----- Original Message -----
From: Hannah Barker
To: Rja Planning & Building Consultants
Sent: Wednesday, April 28, 2010 10:46 AM
Subject: 87B Brighton Road Lancing ADC/0130/10

PROJECT: 87b Brighton Road, Lancing, West Sussex

DRAWING TITLE: Proposed Floor Plans & Elevations

DWG NO: *****-01

Proposed East Elevation

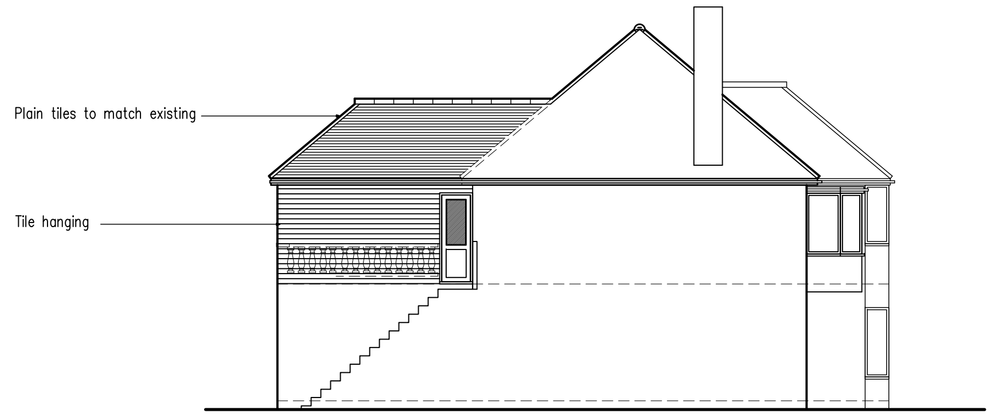
Following submission of the above application I have fully assessed that application and sought advice of my team and based on the proximity of the adjacent window and the overall scale and bulk of the extension I will require the roof to be hipped to reduce the bulk as a minimum. I look forward to receiving an amended plan as soon as possible, and then the application can be determined, subject to agreement of the planning services manager.

B	30.4.10	Amended to suit planning officers comments
A	4.4.10	Extension roof amended to suit clients requirements
